SERVICE BULLETIN

APPLICABILITY: 2019-21MY Crosstrek PHEV

NUMBER: 09-82-23

SUBJECT: DTC P0452 EVAP System (CPC) Pressure Sensor/Switch Circuit Low
Design Changes to Fuel Tank Assembly & Vent Tubes

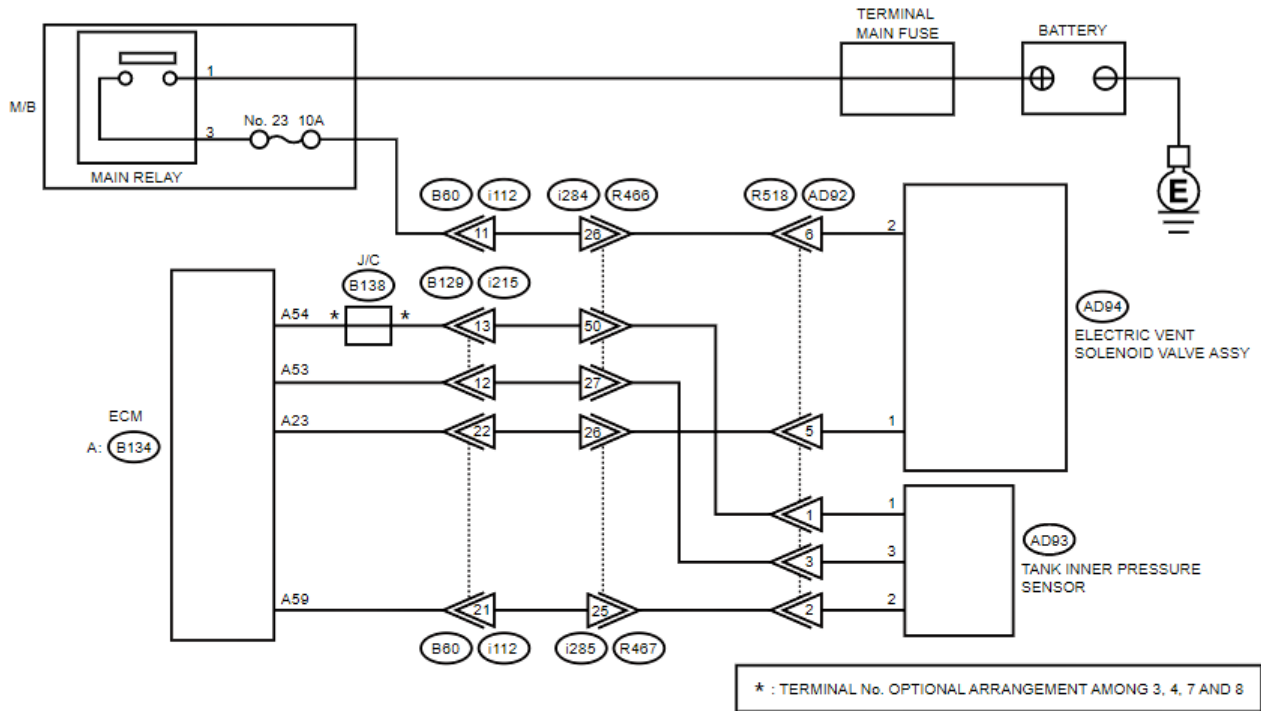
Visually inspect the internal condition of the Evaporative Line connections to the Electronic Vent Solenoid:

1. Resin Tube on the Fuel Tank Assembly (attached directly to the Vent Solenoid)
2. Vent Tube #1
3. Vent Tube #2

If any deposits/build-up is found inside the tube(s), replace all the Vent Tubes and Fuel Tank Assembly.
